NOTICE OF PUBLIC HEARING
Minor Variance

APPLICATION NO.:	A-24:65	SUBJECT PROPERTY:	455 Jones Road, Stoney Creek
ZONE:	“RM3-44” (Multiple Residential)	ZONING BY-LAW:	Zoning By-law former City of Stoney Creek 3692-92, as Amended 12-253

SHEET TITLE: SITE PLAN & ZONING SCHEDULE
 SHEET NO: SP1.01

**Re: APPLICABLE LAW REVIEW – ZONING BYLAW IN SUPPORT OF A BUILDING PERMIT
Present Zoning: RM3-44 (MULTIPLE RESIDENTIAL)
Address: 455 JONES RD, STONEY CREEK, ON**

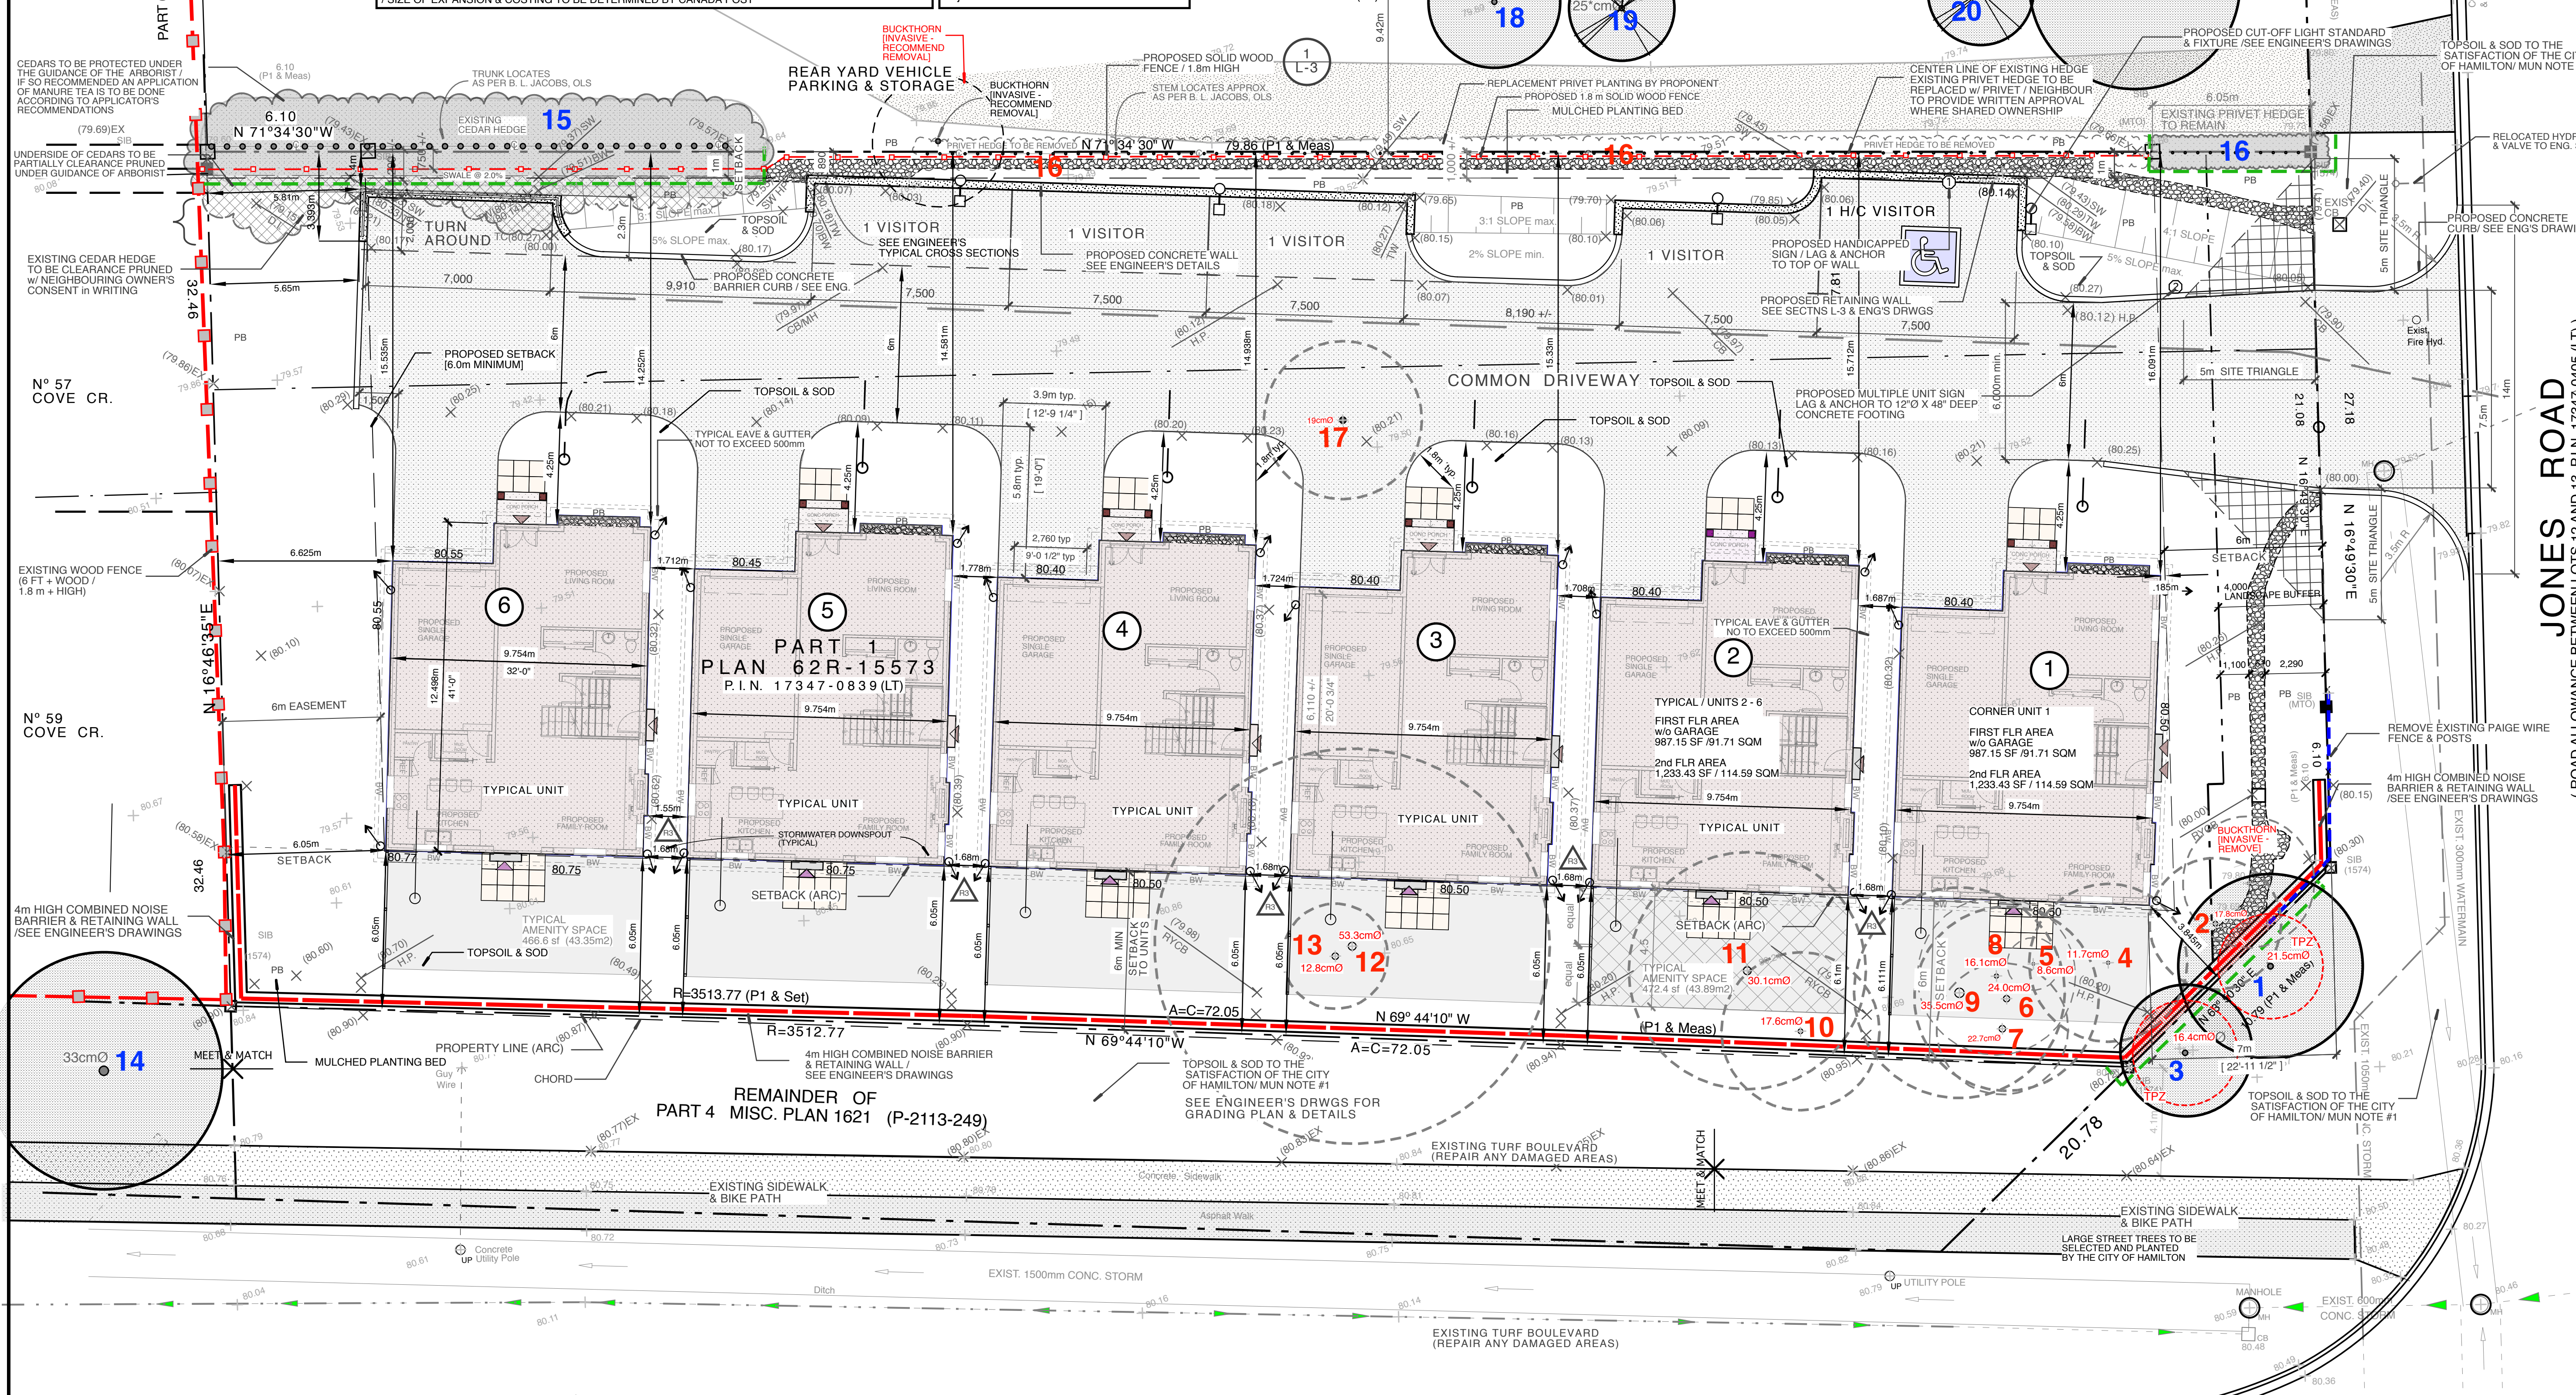
3. This is a corner lot as defined. Therefore, the front lot line is considered Jones Road being the shorter lot line abutting a street. The lot line along North Service Road shall be considered the flankage lot line including the hypotenuse of the daylight triangle and all other lot lines are considered interior side lot lines.

8. Any other encroachments shall comply with the requirements of Section 4.19 of the Stoney Creek Zoning By-law 3692-92.
9. Any proposed accessory buildings shall comply with the requirements of Section 6.1.4 of the Stoney Creek Zoning By-law 3692-92. Currently, the submitted plans show no accessory buildings as part of the proposal.

10. All mechanical equipment including “transformers” shall comply with the requirements of Section 4.16 of the Stoney Creek Zoning By-law 3692-92 and shall not be located within any required landscaped areas. Details regarding any proposed transformer have not been shown from which to determine compliance.

11. Details of the garbage facilities have not been shown; however, the applicant advises that private collection is proposed. Please note any fenced areas which are not roofed-over shall be subject to the fence by-law 10.142. Any garbage enclosures that are required to be roofed-over are considered to be an accessory building and shall subject to the requirements of 6.1.4 of the Stoney Creek Zoning By-law 3692-92.

<p>Parking Regulation - Section 6.10.5 and 6.1.8</p>			
<p>Minimum Number of Parking Spaces [per Section 6.10.5 (a) as amended by Section 6.10.7(c) (a), and Section 4.10.9 Schedule of Minimum Parking Requirements of the Stoney Creek Zoning By-law 3692-92]</p>	<p>A minimum of twelve (12) parking spaces shall be maintained.</p> <p>(a) Minimum Number of Parking Spaces:</p> <p>1. 2 parking spaces and 0.8 visitor parking spaces for each dwelling unit. Tandem parking is permitted for non-visitor parking spaces.</p> <p>Therefore, based on 6 single family dwelling units x 1.2 = 7.2 = 7 spaces (round down)</p> <p>Visitor parking 0.8 spaces per each single detached</p>	<p>(a) The revised site plan shows a total of eleven (11) parking spaces.</p> <p><u>Breakdown:</u></p> <ul style="list-style-type: none"> • One (1) within each of the private garages • One (1) within each of the private driveways • Five (5) surface parallel spaces <p><u>Please note that tandem parking is permitted for each of the dwelling units.</u></p>	<p>Non-conforming</p>

By-law Requirement	Required	Provided	Conforms/ Non-conforming
	dwelling = 4.8 = 5 visitors parking (round up). <u>Total = 12 spaces (7 + 5)</u>		
Location of parking in relation to a Zone for Single detached, semi-detached or duplex dwellings. [per Section 6.10.5 (b) as amended by Section 6.10.7(b), of the Stoney Creek Zoning By-law 3692-92]	(b) No common parking space shall be located closer than 3 metres from a zone for single detached, semi-detached, or duplex dwellings, except that common parking spaces are permitted to be located a minimum of 1 metre from the northerly side lot line	(b) A setback of 1.0m and greater is shown from the surface parallel spaces to the northerly side lot line. The parking areas are located a distance greater than 3.0m from the adjacent residential boundary to the west.	Conforms
Location of parking spaces [per Section 6.10.5 (c) of the Stoney Creek Zoning By-law 3692-92]	For maisonettes or townhouses, only one of the required parking spaces per unit may be provided in the required front yard.	The proposal is for single detached dwellings.	N/A
